PIC16C77 Rev. A Silicon Errata Sheet

The PIC16C77 (Rev. A) parts you have received conform functionally to the Device Data Sheet (DS30390E), except for the anomalies described below.

FIGURE 1: WRITES TO TIMER1 (EXTERNAL CLOCK / OSCILLATOR MODE)

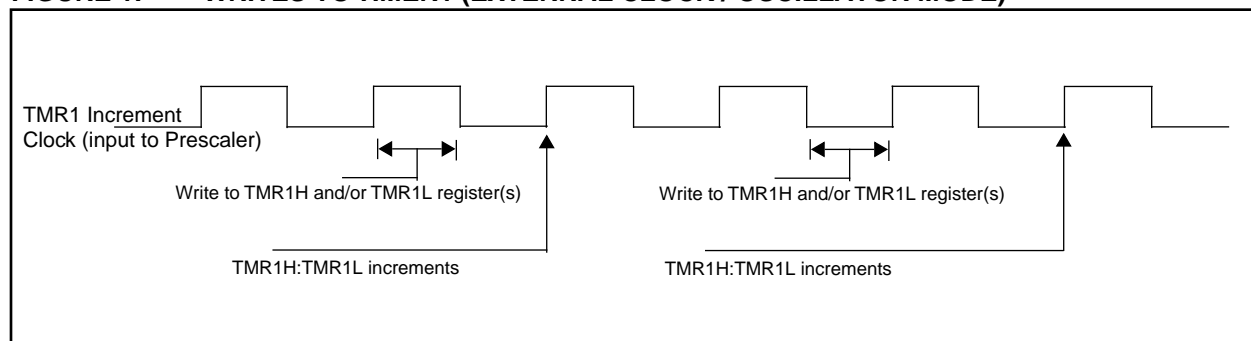
- a) The operation of Timer1 needs some clarification when the timer registers are written when the TMR1ON bit is set.

The internal clock signal that is the input to the TMR1 prescaler affects the incrementing of Timer1 (TMR1H:TMR1L registers and the Timer1 prescaler). When the Timer1 registers are NOT written, the Timer1 will increment on the rising edge of the TMR1 increment clock.

When the TMR1H and/or TMR1L registers are written while this clock is high, TMR1 will increment on the next rising edge of this clock.

When the TMR1H and/or TMR1L registers are written while this clock is low, TMR1 will not increment on the next rising edge of this clock, but must first have a falling clock and the rising clock for TMR1 to increment.

Figure 1 shows the two cases of writes to the TMR1H and/or TMR1L registers. Due to the V_{IH} and V_{IL} thresholds on the oscillator/clock pins, external Timer1 oscillator components, and external clock frequency, the Timer1 increment clock may not be of a 50% duty cycle.

The TMR1 increment clock is out of phase of the T1OSO/T1CKI pin by a small propagation delay.
